Access Compliance Report

Public Rights-of-Way

(Curb Ramps)

Intersection ID: 10025569	Main Street: E_W_T_HARRIS_BV	Cross Street: N/A	Location: NW
ADA ID: F876FDF3E202	Ramp Type: PerpDiag	Initial Pass/Fail: Fail	Overall Compliance: No
Codes/Mitigation Info/Possible Solution		Field Measurements/Component Compliance	
Severity Score: 25

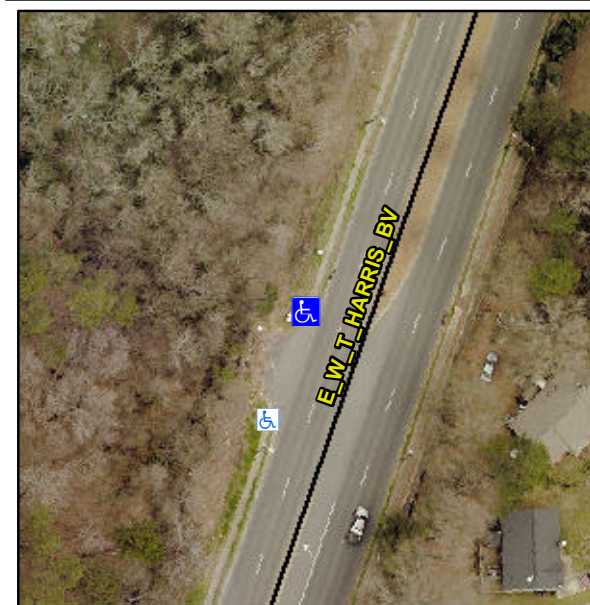
Not Found, R304.2.2, R304.5.3

Compliance	Description	Data	Compliance	Description	Data
N/A	Ramp Length (in)	68.0	No	Ramp Slope (%)	8.9
Yes	Ramp Width (in)	48.0	No	Ramp XSlope (%)	5.6
N/A	Flare Type LT	N/A	N/A	Flare Type RT	N/A
N/A	Flare Slope LT (%)	N/A	N/A	Flare Slope RT (%)	N/A
N/A	Flare Traversable LT?	N/A	N/A	Flare Traversable RT?	N/A
N/A	Landing Length (in)	N/A	N/A	DWS Provided?	N/A
N/A	Landing Width (in)	N/A	N/A	DWS Contrast?	N/A
N/A	Landing Slope (%)	N/A	N/A	DWS Length (in)	N/A
N/A	Landing X Slope (%)	N/A	N/A	DWS Full Width?	N/A
N/A	Landing Curb? (Y/N)	N/A	N/A	DWS Offset (in)	N/A
N/A	Shared Landing?	N/A			
N/A	Gutter Ponding?	N/A	N/A	Gutter Slope (%)	N/A
N/A	Gutter Lip Ht (in)	N/A	N/A	Gutter X Slope (%)	N/A
N/A	Painted X Walk1?	No	N/A	Painted X Walk2?	No
	X Walk 1 Direction	To SW		X Walk 2 Direction	To SE
N/A	X Walk 1 Width (in)	N/A	N/A	X Walk 2 Width (in)	N/A
	X Walk 1 Slope (%)	3.2		X Walk 2 Slope (%)	5.5
	X Walk 1 X Slope (%)	1.0		X Walk 2 X Slope (%)	3.2

Remove & Replace Curb Ramp With Two New Directional Ramps or Equivalent.
